MOORE SCHOOL OF ELECTRICAL ENGINEERING UNIVERSITY OF PENNSYLVANIA			
FRONT AND BACK RACK FEET			
MATERIAL: 1/4" Angle Iron		FINISH: WRINKLED BLACK	SCALE: 1/6 Full Size (Approx.)
DRAWN BY: DDJ Dec. 20, 1943	CHECKED BY: 7-21-44	APPROVED BY: 7-21-44	PX-3-23

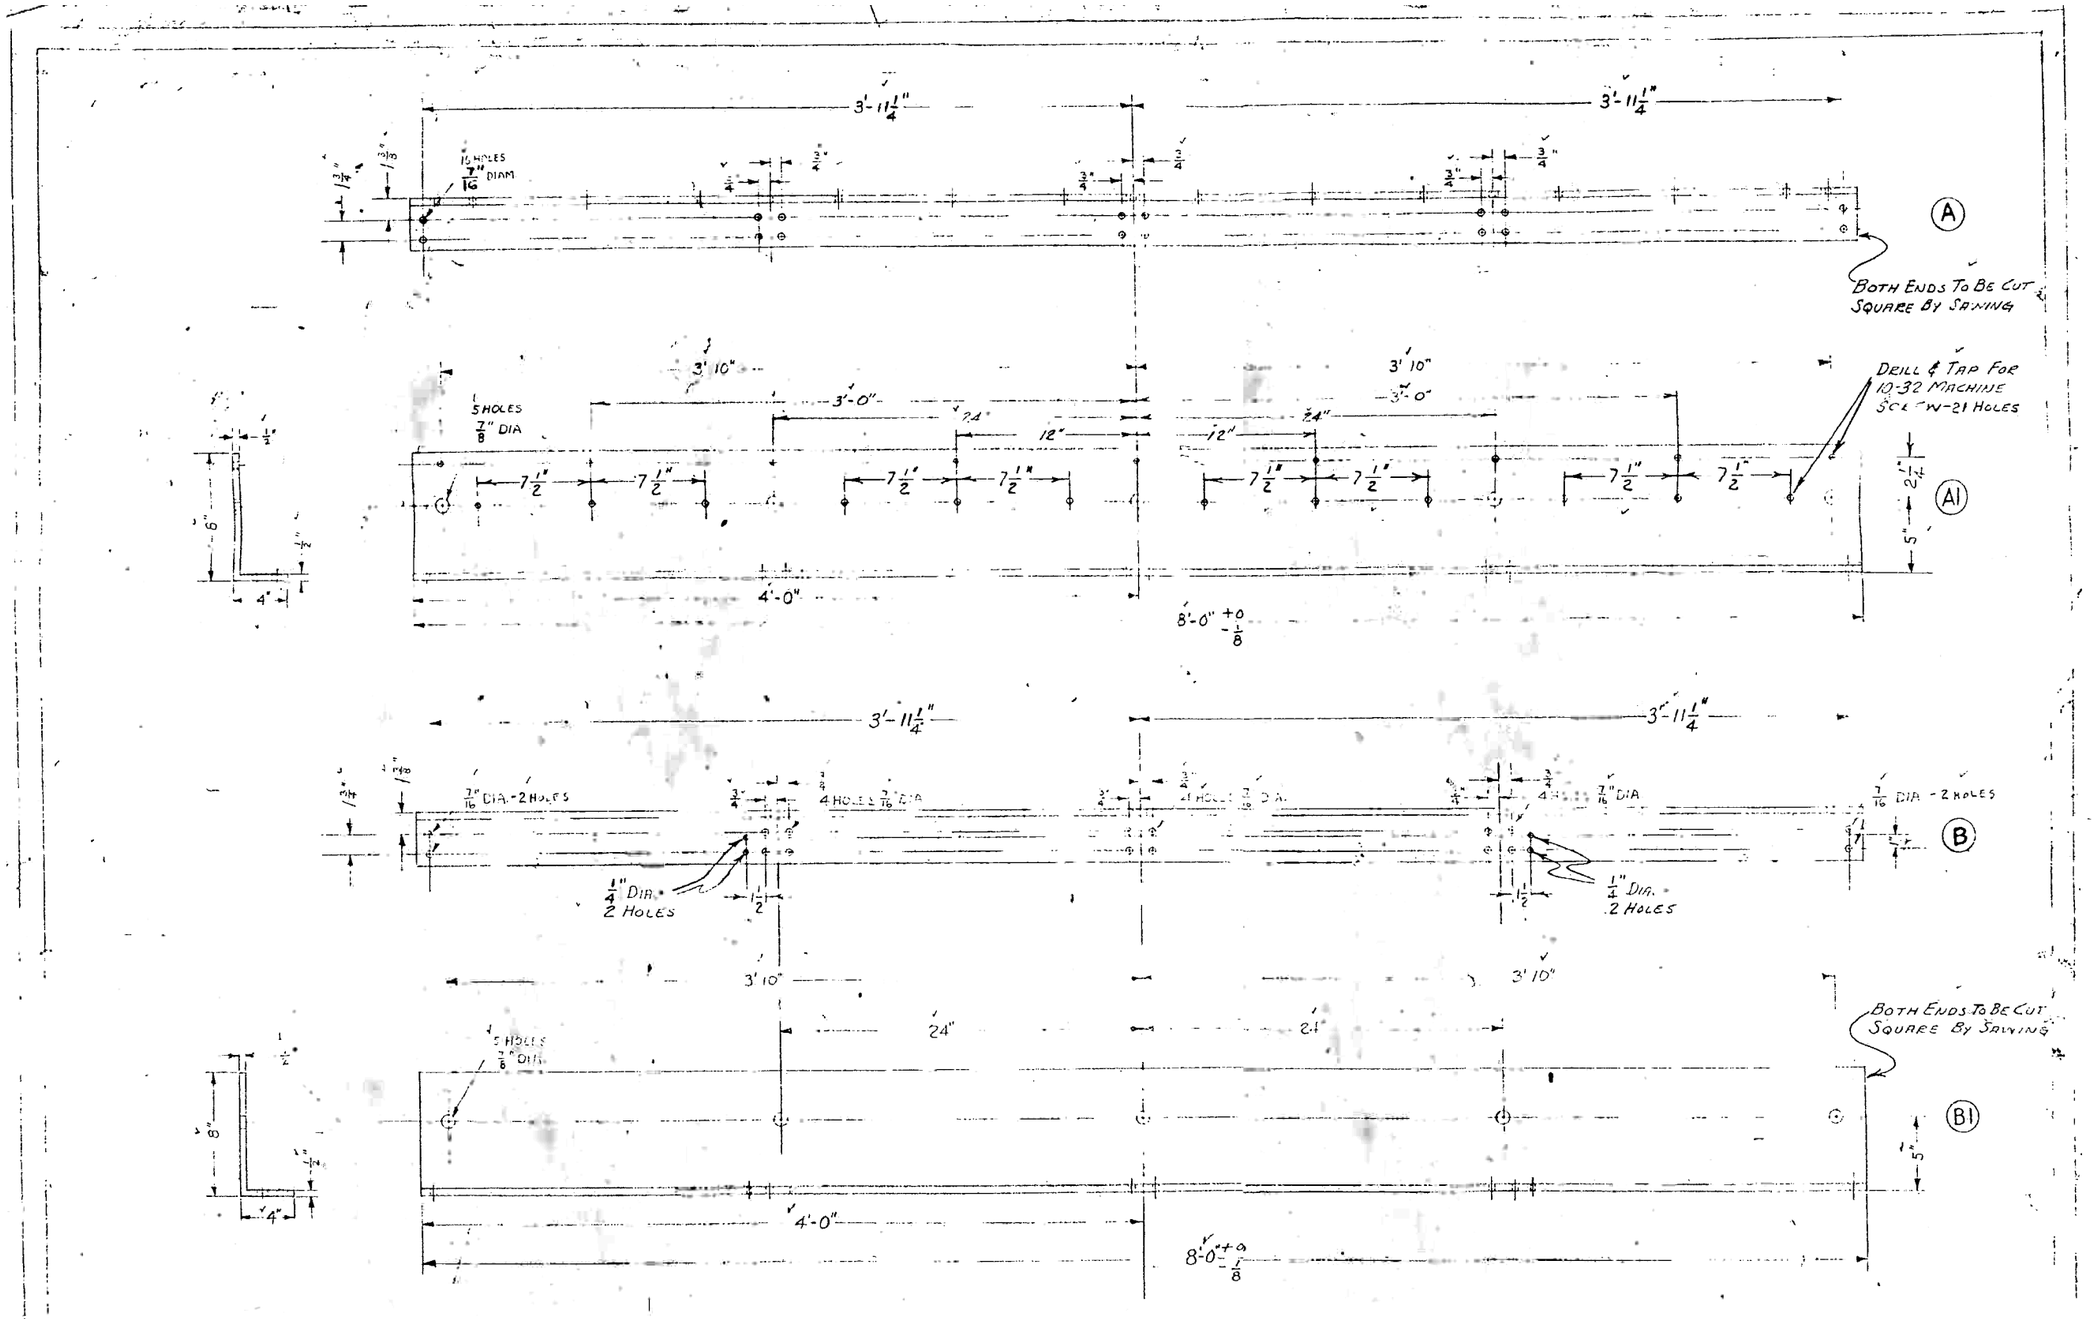
A AND B WERE SIMILAR. 10-32 TAPPED HOLES AND 1/4" DIA. HOLES ADDED

4 - 1/4" DIA. HOLES WERE OMITTED - REMAINING 4 - 1/4" DIA. HOLES WERE RELOCATED. TOLERANCE TABLE ADDED. 12 - 10-32 TAPPED HOLES ADDED. 3'-11 3/4" DIM. WAS 3'-11 3/16" FINISH ADDED.

CODE LETTERS A1 & B1 ADDED - USED TO IDENTIFY SPARS ON SHEET
